06-2025 Latest Revision Date Approved by Bridge Engineer	 Standard Design <b>Steel Overhead Sign Truss</b> September, 2011	
	DMS Runway Gate Details 50'-130' Spans	<b>SOST-14-11</b>

**Gate Detail Plan**

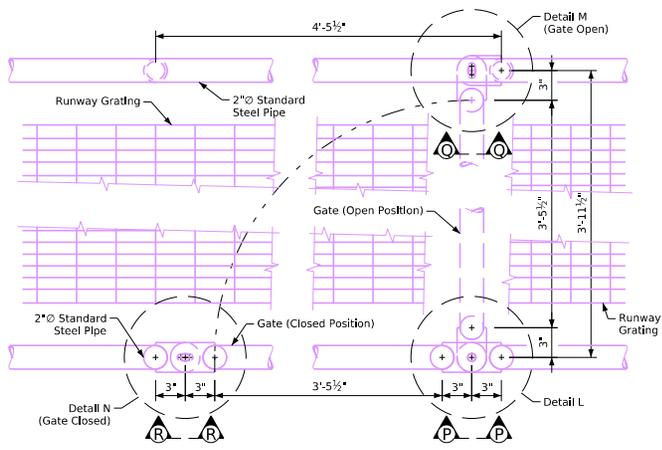
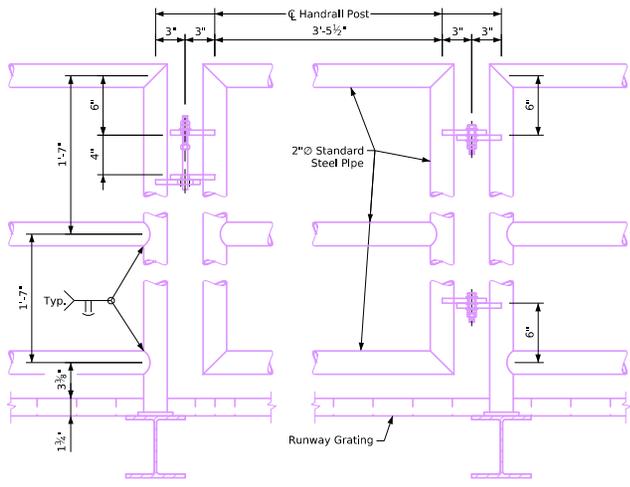
\*Revised 06-2025: Corrected horizontal distance between DMS access runway handrails to 3'-1 1/2" (was 3'-11") for consistency with dimensions shown on SOST-13-11, Section L-L. Changed width of handrail gate from 3'-5" to 3'-5 1/2" and width of handrail gate opening from 4'-5" to 4'-5 1/2" to facilitate proper functioning of latch when gate is in open position. This sheet reassued, sheet format update.  
 -steeloverheadsigntruss.dgn - SOST-14-11 - This sheet issued 03-2013.
